AR-313

**Comments of Public Service Company of New Hampshire
on EPA's Draft National Pollutant Discharge Elimination
System Permit No. NH 0001473 for Schiller Station**

Permit No. NH0001473

Schiller Station

Figure 2-1: Example illustrating the decline in abundance of Winter Flounder life stages from spawning to adulthood based on published life history parameters³.

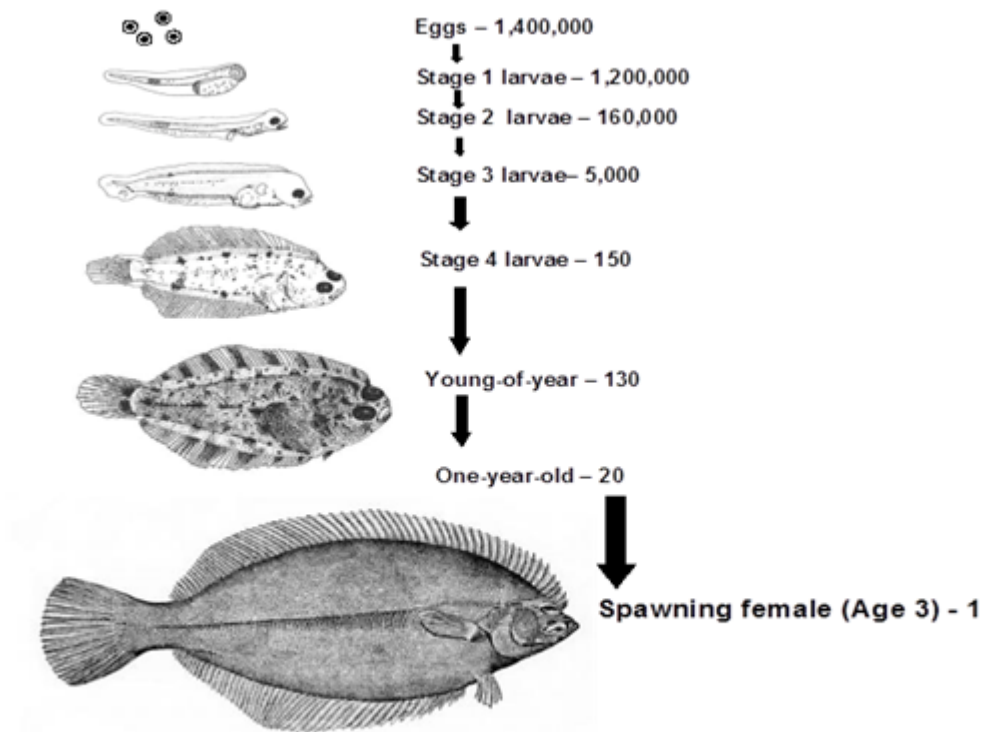
Figure 2-1 in the 2016 Enercon-Normandeau Comments depicts the survivorship curve of the Winter Flounder and puts the above-referenced comments in proper context by demonstrating

that a miniscule number of eggs and larvae of organisms subject to entrainment at Schiller Station would survive to adulthood even in the absence of the facility's CWISs:

Only one out of 1.4 million Winter Flounder eggs is likely to survive in waters similar to the Piscataqua River to become a three-year-old spawning fish—one.¹¹⁸ Moreover, nearly 99 percent of the eggs die of natural causes within 60 days following spawning. Remarkably, fecundities of other abundant fish and macrocrustacean taxa typically entrained by CWISs at Schiller Station are roughly equivalent to the Winter Flounder and/or are comparatively higher than the median taxa. Furthermore, like the Winter Flounder, early life stages of these other abundant fish and macrocrustacean taxa typically entrained by the facility's CWISs also
